# UNITED STATES PATENT AND TRADEMARK OFFICE

APPLICATION NO.	FILING DATE	FIRST NAMED INVENTOR	ATTORNEY DOCKET NO.	CONFIRMATION NO.
10/769,962	02/02/2004	Darin G. Schaeffer	10703/042	9118

**Office Action Summary**

## **DETAILED ACTION**

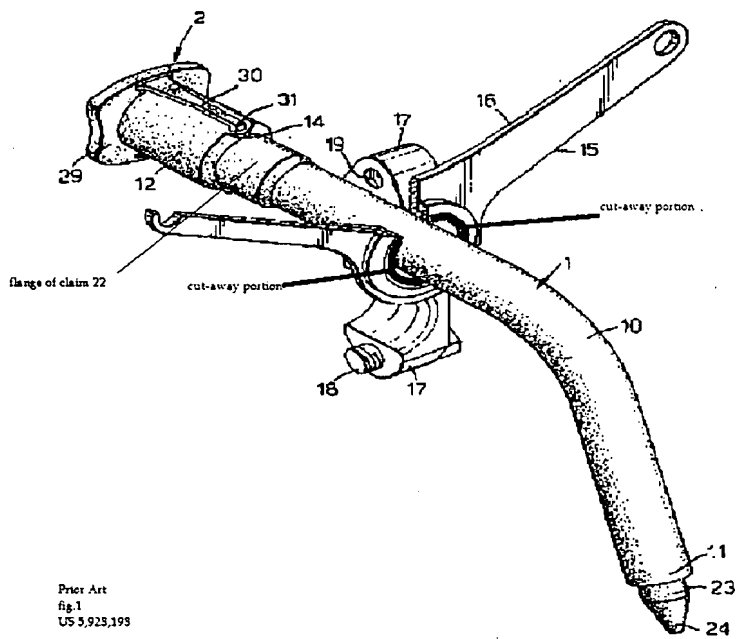
through, said tracheotomy tube having a distal end (11) portion precutaneous insertable into said trachea and a proximal end (toward 12) portion exterior to the trachea when said distal end portion is inserted; said tracheotomy tube further having a radially extending flange (see labeled fig.1, attached below). Lester further teaches said flange is attachable to said proximal end portion of the tracheotomy tube after said distal end portion has been inserted into the trachea so that the flange can be locked at any location along the trachea tube as applied for claim 1. Lester further discloses a dilator (2) positionable within said longitudinal passageway of said tracheotomy tube (fig.1) for dilating an opening in said trachea for insertion of said tracheotomy tube; and a locking assembly (28,30,31) for locking the tracheotomy tube to the dilator during insertion of said tracheotomy tube into the trachea.

**As to claim 4**, Lester discloses wherein said flange includes a cut-away portion (see labeled fig.1, attached below), collar (12), however, lacks wherein said collar having a groove, and said groove being cooperatively sized and shaped to mate when said flange is attached to said tube, however, Montgomery teaches grooves on an endotracheal tube can serve to secure the apertures face plate 20 (flange) (see col.3 lines 17-20). Therefore, it would have been obvious to
